THE ILLINOIS STATE TOLL HIGHWAY AUTHORITY

BASE SHEETS

MARCH 2024

Illinois Tollway Base Sheet Revisions

**OVERHEAD SIGN STRUCTURE
ITS GANTRY FRAME (STEEL)
SINGLE SPAN STRUCTURE
DETAILS**

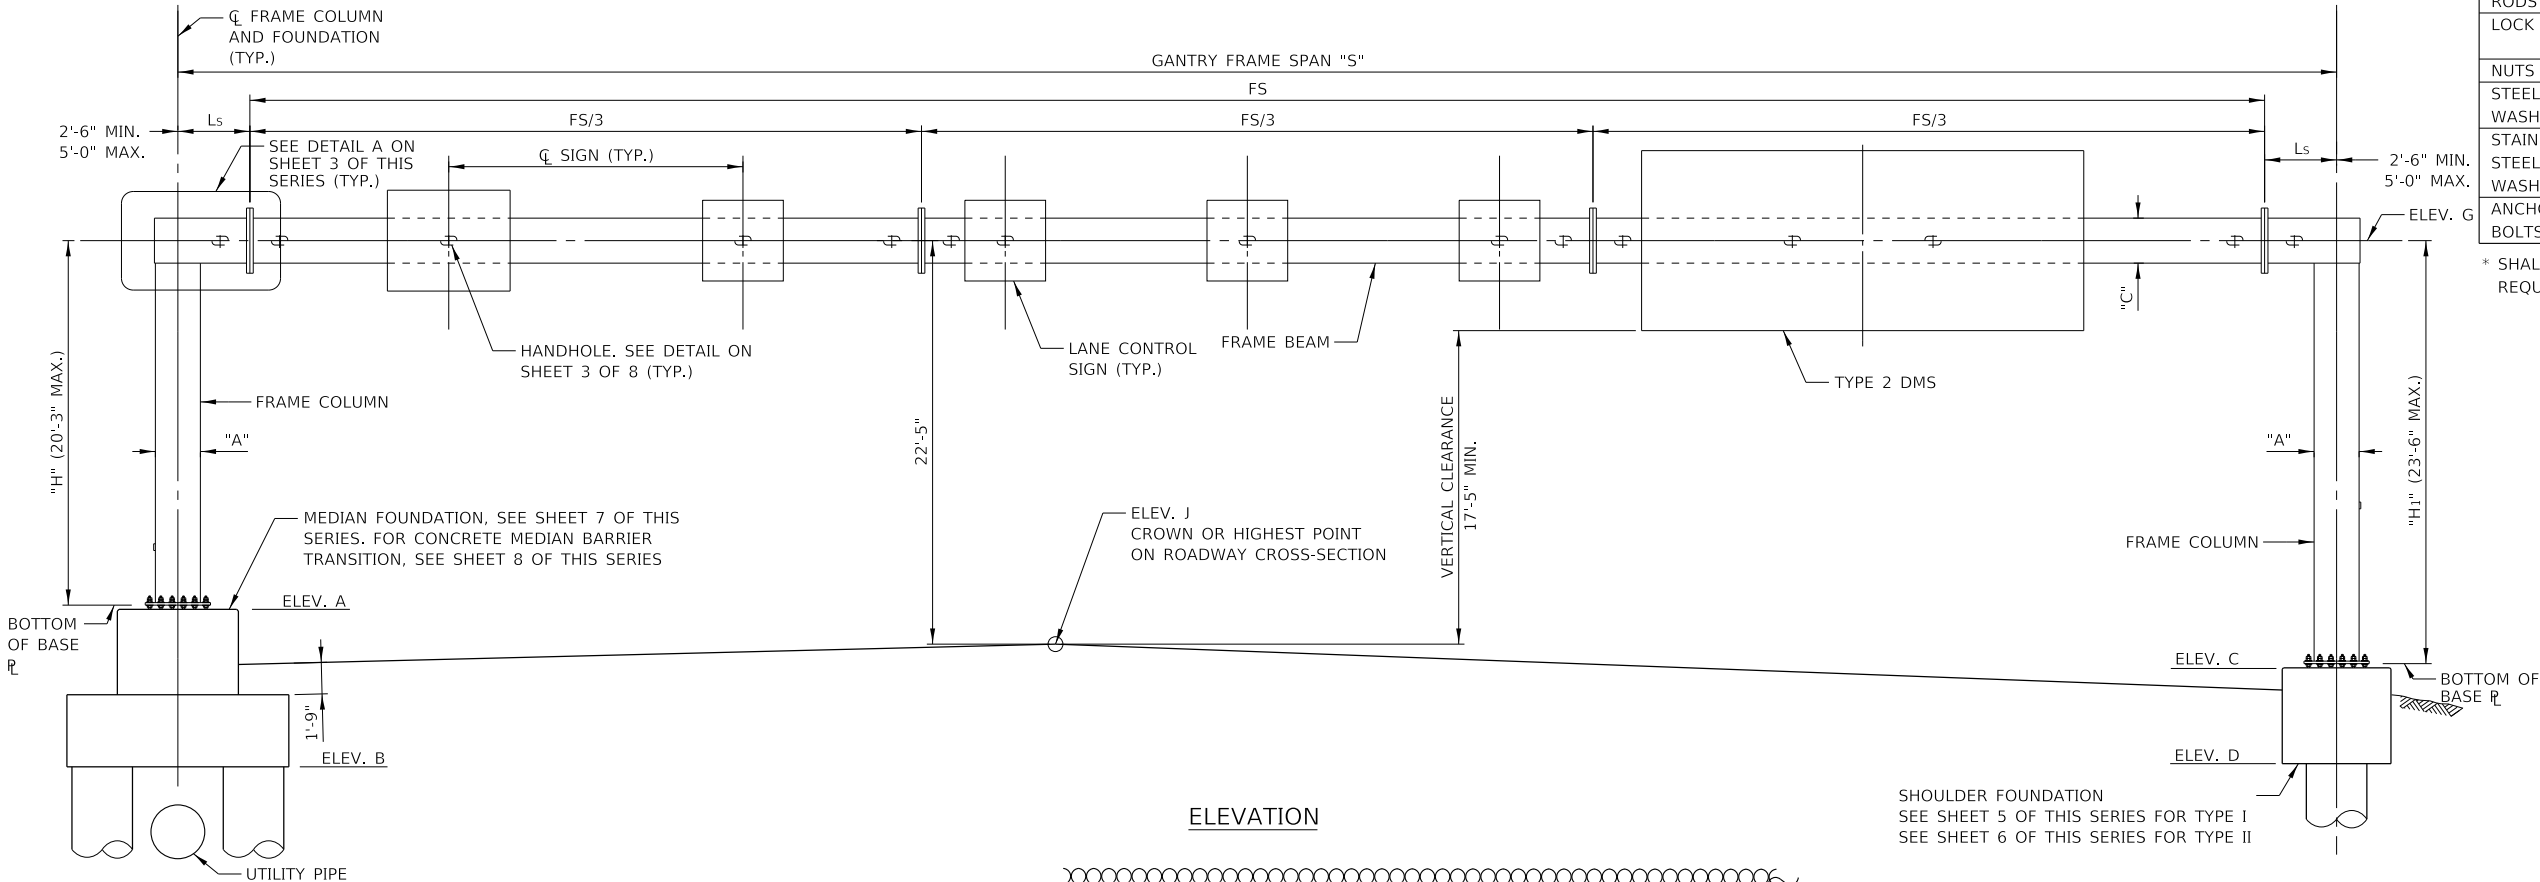
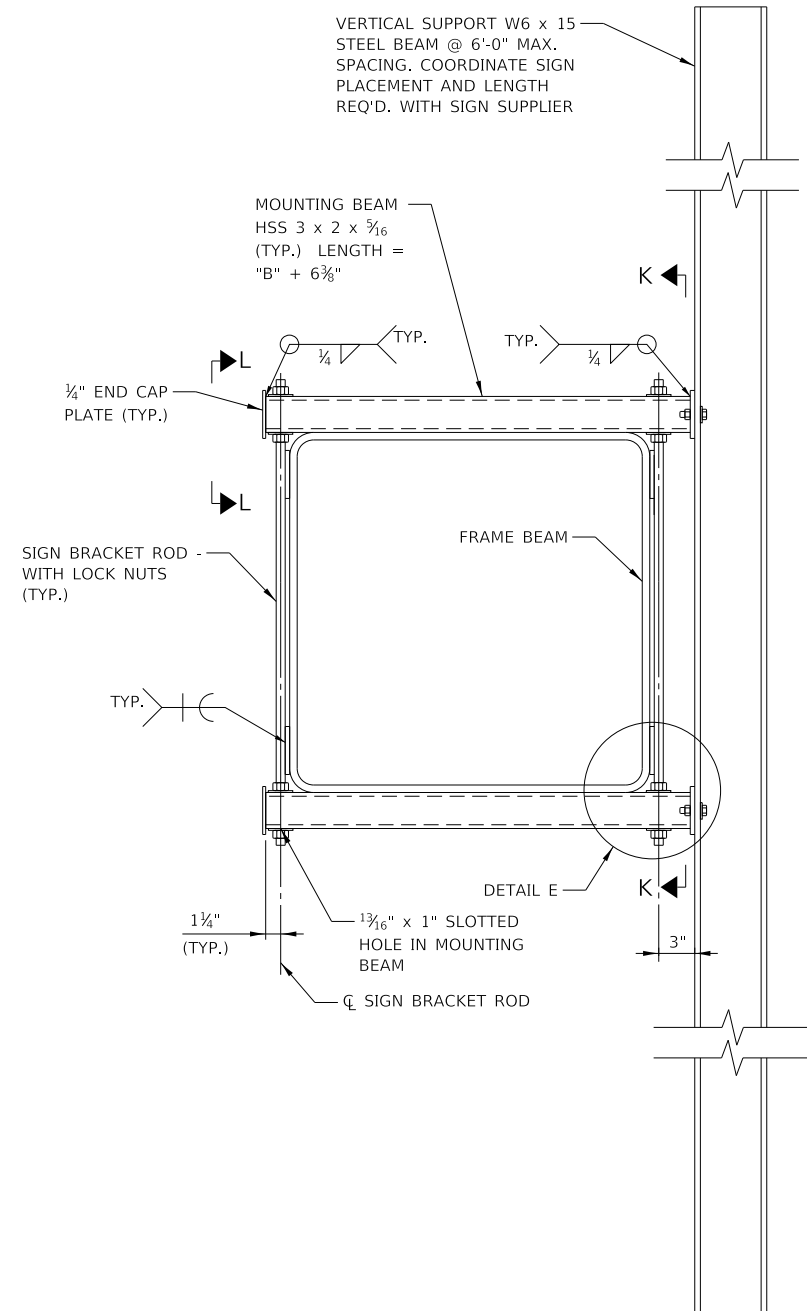
Sheet 3	Revised the connection "Detail A" and eliminated the diagonal stiffener.	
		Revised the welding details shown for the beam to column connection.	
		Revised Section G-G to account for new connection details.	
		Section A-A is drawn to clarify the new connection details.

**OVERHEAD SIGN STRUCTURE
ITS GANTRY FRAME (STEEL)
TWO-SPAN STRUCTURE
DETAILS**

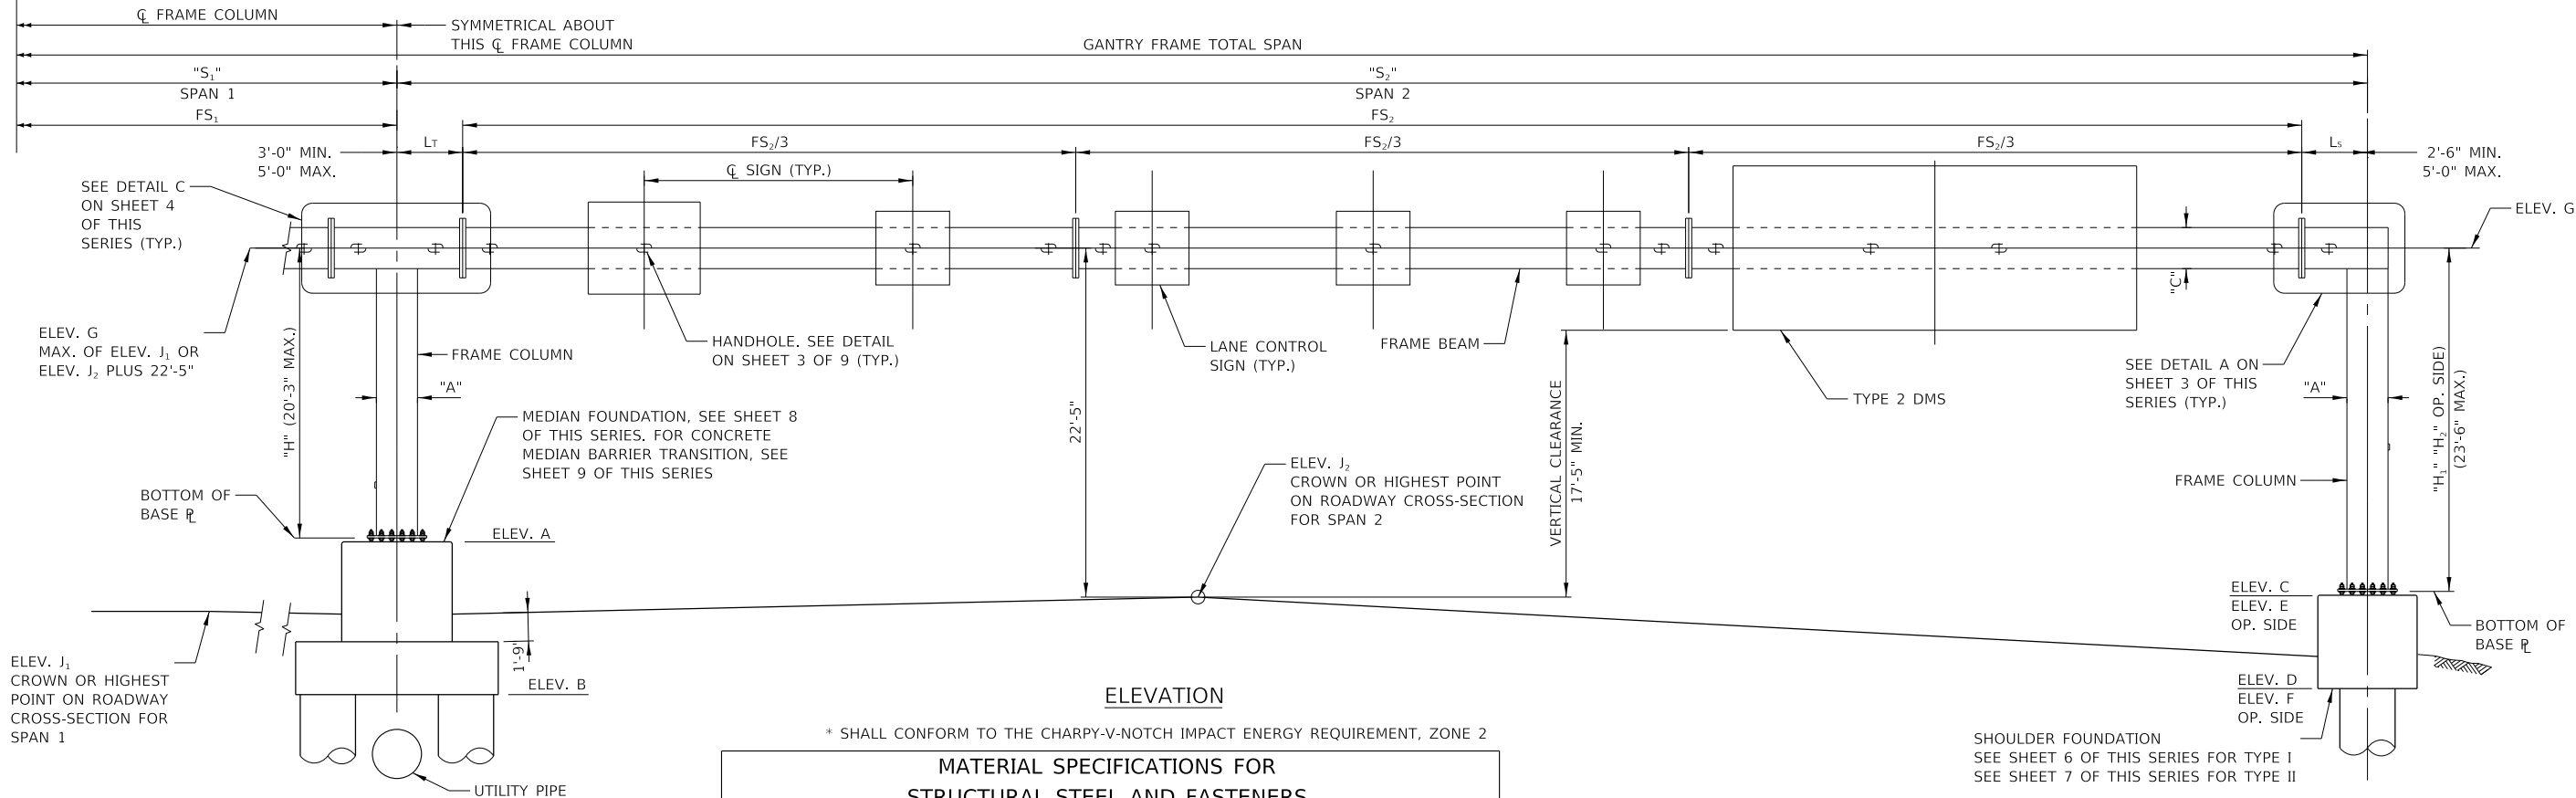
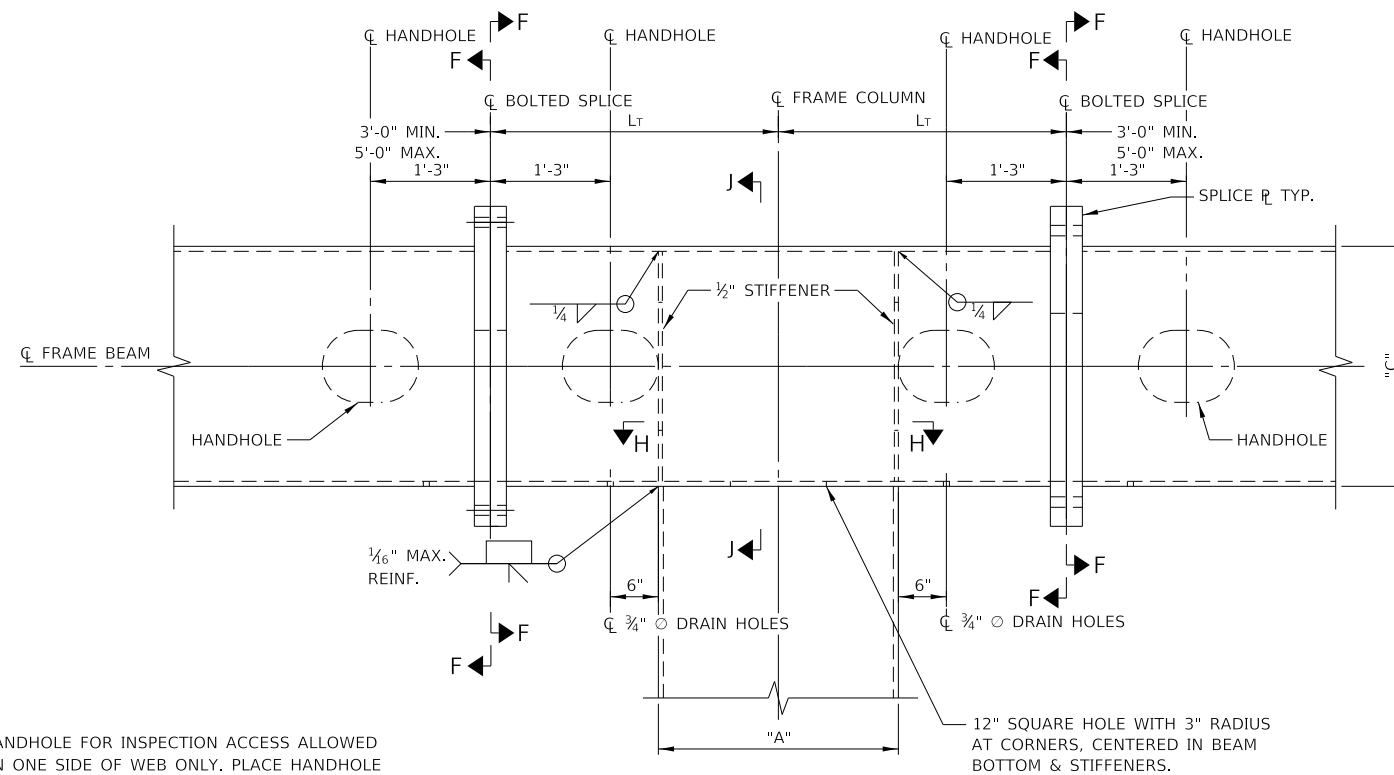
Sheet 3	Revised the connection "Detail A" and eliminated the diagonal stiffener.	
		Revised the welding details shown for the beam to column connection.	
		Revised Section G-G to account for new connection details.	
		Section A-A is drawn to clarify the new connection details.
